Office Action Summary

10/593,534

HATRICK-SMITH, JOHN

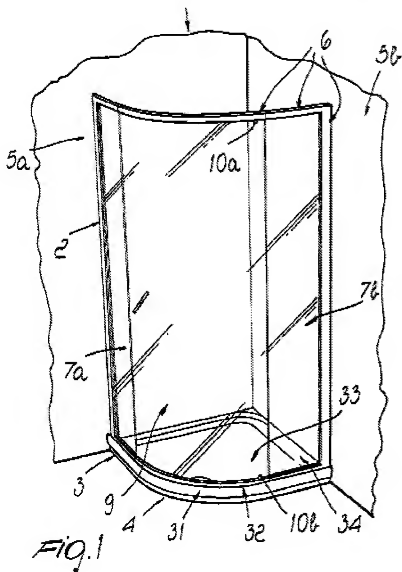
4. Claims 25 and 28 are rejected under 35 U.S.C. 103(a) as being unpatentable over Montanari in view of Payne. The Montanari reference discloses a shower enclosure comprising: a door 9 and return panels 7a/b on both sides of the door; a shower base 3 including a floor 33; a waste outlet 35; a drain channel 34; and a return panel 7a, as claimed. Re claim 25, the "non-sealed gap" is depicted in Fig. 8 Re claim 28, the "non-sealed gap" is depicted in Figure 1 below (see col. 4, lines 5-17 and 28-55). Montanari discloses all of the limitations except for the formations at the edge. Attention is directed to the Payne reference which discloses an analogous shower which further includes a base 1 having a formation 12. Therefore, in consideration of

Payne, it would have been obvious to one of ordinary skill in the shower art to associate a formation with the Montanari base in order to facilitate wall support.

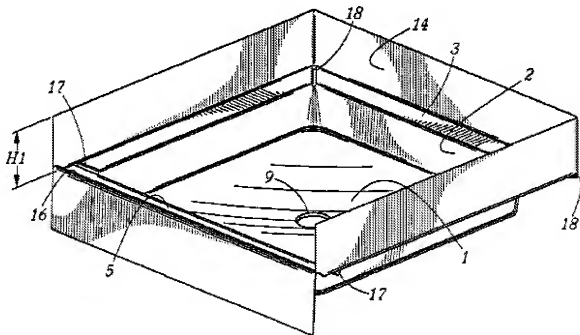
13. Claims 46 and 49 are rejected under 35 U.S.C. 103(a) as being unpatentable over Montanari and Payne and Jurek as applied to claims 25 and 36 above and further in view of Torres (US Patent 7490371). Although Montanari in view of Payne does not have a formation in the form of a step, as claimed, attention is directed to Torres. An analogous art, Torres reference teaches in figure 3, a formation having a step 2, 3 formed at a peripheral edge of the floor of the shower base to receive a foot of the return panel from the shower base. Therefore, in consideration of Torres, it would have been obvious to one of ordinary skill in the shower art to associate a formation comprising a step with the base in order to support the panel/door away from the base surface.

Fig. 2

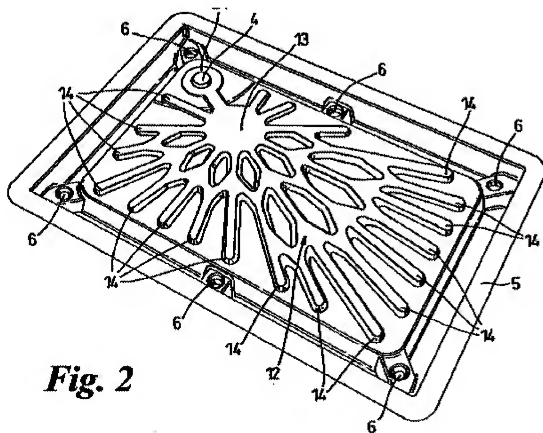
14. Claims 47 and 48 are rejected under 35 U.S.C. 103(a) as being unpatentable over Montanari and Payne as applied to claim 25 above and further in view of Lewis

(PG PUB 20060182926. Although Montanari in view of Payne do not disclose cut-outs in the base, as claimed, attention is directed to Lewis. The Lewis reference teaches in the figure below, a cut-out 6, 13, 14, 4 in the analogous shower base. Therefore, in consideration of Lewis, it would have been obvious to one of ordinary skill in the shower art to associate cut-outs with the base in order to support the panel/door away from the base surface.
